Access Compliance Report

Public Rights-of-Way

Intersection ID: 5741	Main Street: MALLARD_CREEK_RD	Cross Street: NEVIN_RD	Location: SW
ADA ID: 274BAA084366	Ramp Type: Perp	Initial Pass/Fail: Fail	Overall Compliance: No
		Severity Score: 10

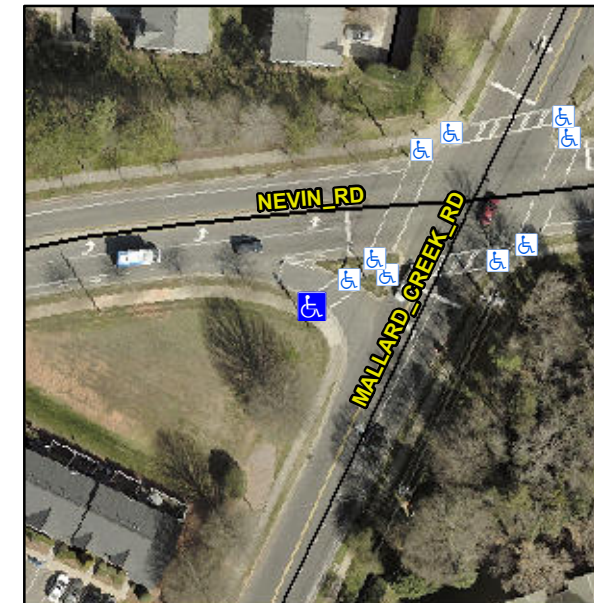
Not Found, R304.5.1, R304.5.3

Compliance	Description	Data	Compliance	Description	Data
N/A	Ramp Length (in)	70.0	Yes	Ramp Slope (%)	6.5
No	Ramp Width (in)	47.0	No	Ramp XSlope (%)	2.3
N/A	Flare Type LT	N/A	N/A	Flare Type RT	N/A
N/A	Flare Slope LT (%)	N/A	N/A	Flare Slope RT (%)	N/A
N/A	Flare Traversable LT?	N/A	N/A	Flare Traversable RT?	N/A
N/A	Landing Length (in)	N/A	N/A	DWS Provided?	N/A
N/A	Landing Width (in)	N/A	N/A	DWS Contrast?	N/A
N/A	Landing Slope (%)	N/A	N/A	DWS Length (in)	N/A
N/A	Landing X Slope (%)	N/A	N/A	DWS Full Width?	N/A
N/A	Landing Curb? (Y/N)	N/A	N/A	DWS Offset (in)	N/A
N/A	Shared Landing?	N/A			
N/A	Gutter Ponding?	N/A	N/A	Gutter Slope (%)	N/A
N/A	Gutter Lip Ht (in)	N/A	N/A	Gutter X Slope (%)	N/A
N/A	Painted X Walk1?	Yes	N/A	Painted X Walk2?	N/A
	X Walk 1 Direction	To NE		X Walk 2 Direction	N/A
N/A	X Walk 1 Width (in)	125.0	N/A	X Walk 2 Width (in)	N/A
	X Walk 1 Slope (%)	0.9		X Walk 2 Slope (%)	N/A
	X Walk 1 X Slope (%)	1.7		X Walk 2 X Slope (%)	N/A

Remove & Replace Entire Ramp.
